UNITED STATES ENVIRONMENTAL PROTECTION AGENCY  
REGION 8

Re: EPA's Comments on the North Dakota  
Department of Health's April 2010 Draft  
BACT Determination for NO<sub>x</sub> for the  
Milton R. Young Station

This letter transmits the United States Environmental Protection Agency's (EPA's) comments on the North Dakota Department of Health's (NDDH's) April 2010, Draft Best Available Control Technology (BACT) Determination for Nitrogen Oxides (NO<sub>x</sub>) for Milton R. Young Station (MRYS), Units 1 and 2 (Draft BACT Determination).

**Figure 1: Comparison of Capital Costs Using Different Cost Methods**

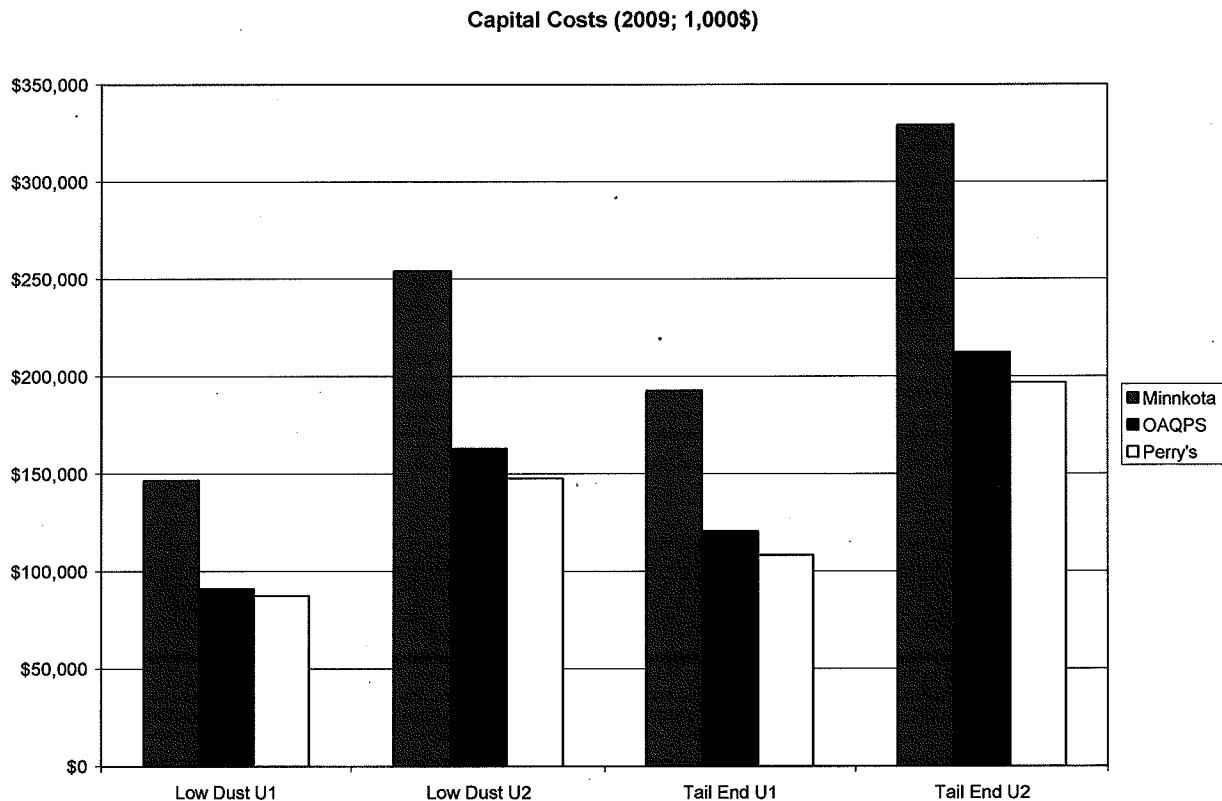
Because B&McD's cost factors are higher than both the Control Cost Manual and Perry's factors, EPA calculated two additional capital cost cases for comparison. Both cases used the same format as in B&McD's estimate, but used the Control Cost Manual and Perry's cost factors, where available. ERG used the 2009 B&McD's SCR costs which were back-calculated from the 2018 costs provided by Minnkota.<sup>44</sup> As can be seen from Table 4 and Figure 1, the capital costs estimated by B&McD for Minnkota are much higher than both the Control Cost Manual and Perry's. The Control Cost Manual and Perry's methods compare favorably.

<b>Table 4. Capital Cost Comparison</b>				
<b>Capital Costs (2009, 1,000\$)</b>	<b>Low Dust U1</b>	<b>Low Dust U2</b>	<b>Tail End U1</b>	<b>Tail End U2</b>
Minnkota	\$146,753	\$254,175	\$192,830	\$329,150
OAQPS	\$91,114	\$162,999	\$120,629	\$212,529
Perry's	\$87,613	\$147,699	\$108,416	\$196,954

**Figure 2: Comparison of Annual Costs Using Different Cost Methods**

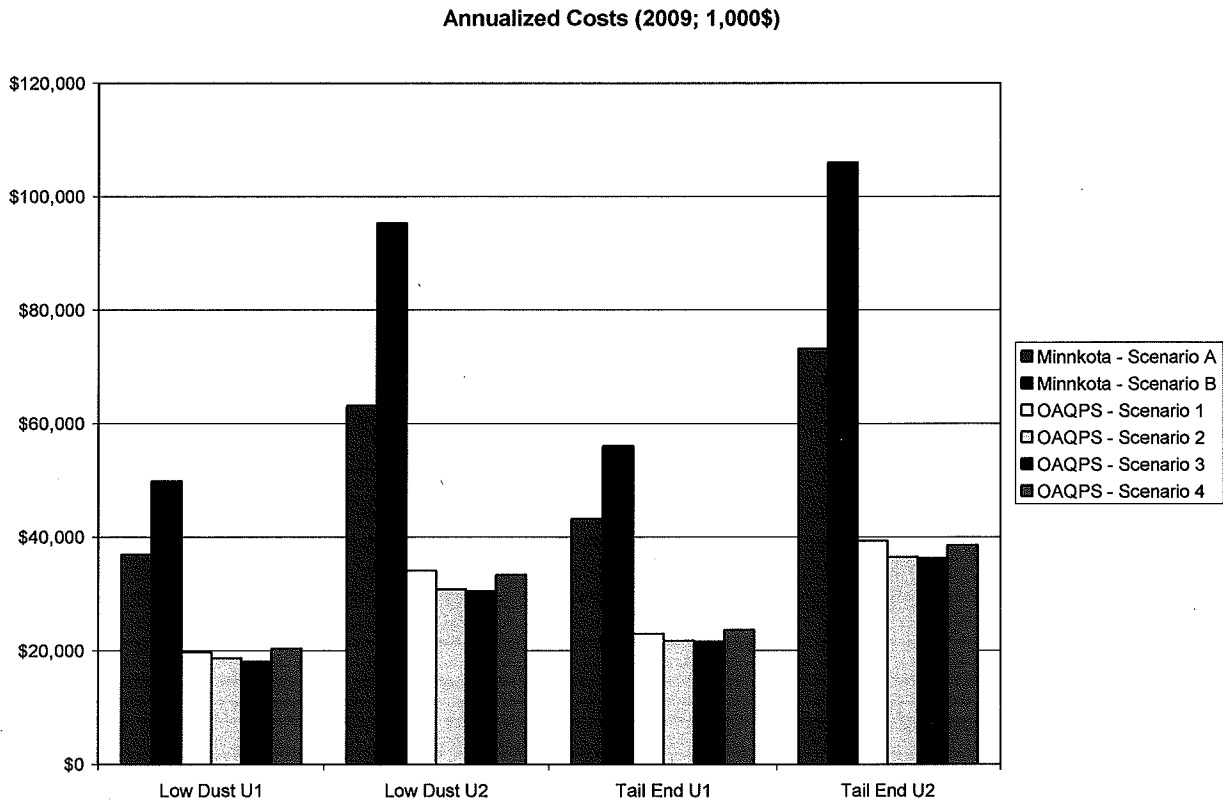
ERG used the above information and calculated annual costs. ERG calculated four different catalyst replacement scenarios. Scenarios 1 through 3 assume catalyst replacement of one layer per year, one layer every two years, and one layer every three years. EPA believes Scenario 3 is the most appropriate, as it reflects the performance guarantees provided by three catalyst vendors in response to Mr. Hartenstein’s RFP and the proposals provided to Minnkota by one vendor. No calculations were made for the “Scenario B” assumptions used by B&McD because, as EPA has stated previously and is well-documented in Mr. Hartenstein’s expert report, these assumptions are unsubstantiated and arbitrary. ERG’s Scenarios 1-3 do not include downtime for ASOFA because this has not been justified by Minnkota. Scenario 4 was run as the “worst-case” scenario and assumes all of the additional outage time is based on the additional outage times estimated for ASOFA provided by B&McD. There would be no additional unit outage time (and associated electricity costs) for catalyst replacement, because all of this work could be completed within the time allocated for ASOFA maintenance. As noted above, EPA does not necessarily concur that these additional outage times for ASOFA are legitimate and believes they should be justified by Minnkota. ERG modified the amount of time required for each catalyst layer replacement from B&McD’s assumptions, recalculated the unit availability using the revised downtime, and recalculated electricity costs and corresponding NO<sub>x</sub> emissions using the new availability. Table 5 shows the costs for each scenario. The annual costs in this table include the annual costs associated with capital recovery.

Table 5. Annual Cost Comparison				
Annual Costs (2009, 1,000\$)	Low Dust U1	Low Dust U2	Tail End U1	Tail End U2
Minnkota - Scenario A	\$36,923	\$63,162	\$43,290	\$73,245
Minnkota - Scenario B	\$49,829	\$95,310	\$56,098	\$106,022
OAQPS - Scenario 1	\$19,753	\$34,114	\$23,016	\$39,345
OAQPS - Scenario 2	\$18,714	\$30,837	\$21,768	\$36,464
OAQPS - Scenario 3	\$18,081	\$30,524	\$21,660	\$36,287
OAQPS - Scenario 4	\$20,449	\$33,370	\$23,708	\$38,598

**Figure 2: Comparison of Cost-Effectiveness Using Different Cost Methods**

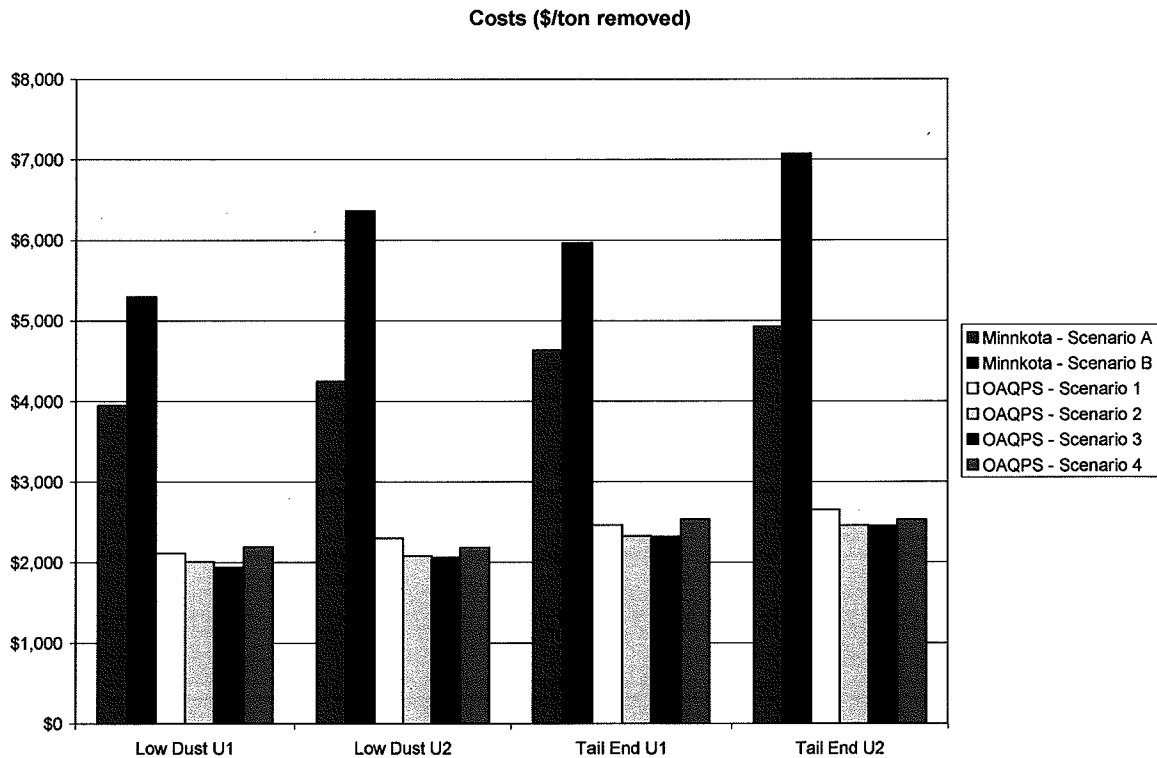
Table 6 shows the costs in dollars per ton of NO<sub>x</sub> removed in both 2009 and 2006 dollars. North Dakota averaged B&McD's Scenario A and B in their summary, which is also shown on the table. As can be seen from the table, when the Control Cost Manual cost factors are used in conjunction with baseline cost information provided by B&McD, supplemented with more reasonable cost data and assumptions on certain cost data, the cost-effectiveness is less than half of the "average" value of the two B&McD scenarios used by NDDH, even under the assumption that a layer of catalyst is replaced is every year (Control Cost Manual Scenario 1). This assumption is three times higher than the catalyst exchange rate that was provided in proposals from one catalyst vendor to Minnkota and performance guarantees provided to Mr. Hartenstein from three catalyst vendors. ERG's analysis is attached.<sup>45</sup>

<b>Table 6. Cost Comparison Dollar per Ton Removed</b>				
<b>2009 Dollars (1,000\$)</b>				
<b>Annual Costs</b>	<b>Low Dust U1</b>	<b>Low Dust U2</b>	<b>Tail End U1</b>	<b>Tail End U2</b>
Minnkota - Scenario A	\$3,950	\$4,250	\$4,632	\$4,930
Minnkota - Scenario B	\$5,300	\$6,362	\$5,969	\$7,078
North Dakota	\$4,625	\$5,306	\$5,301	\$6,004
OAQPS - Scenario 1	\$2,120	\$2,301	\$2,464	\$2,654
OAQPS - Scenario 2	\$2,010	\$2,081	\$2,332	\$2,461
OAQPS - Scenario 3	\$1,942	\$2,061	\$2,321	\$2,451
OAQPS - Scenario 4	\$2,194	\$2,188	\$2,537	\$2,531
<b>2006 Dollars (1,000\$)</b>				
Minnkota - Scenario A	\$3,586	\$3,859	\$4,206	\$4,476
Minnkota - Scenario B	\$4,813	\$5,777	\$5,420	\$6,426
North Dakota	\$4,200	\$4,818	\$4,813	\$5,451
OAQPS - Scenario 1	\$1,925	\$2,089	\$2,238	\$2,410
OAQPS - Scenario 2	\$1,825	\$1,890	\$2,117	\$2,235
OAQPS - Scenario 3	\$1,764	\$1,872	\$2,108	\$2,225
OAQPS - Scenario 4	\$1,992	\$1,987	\$2,304	\$2,298
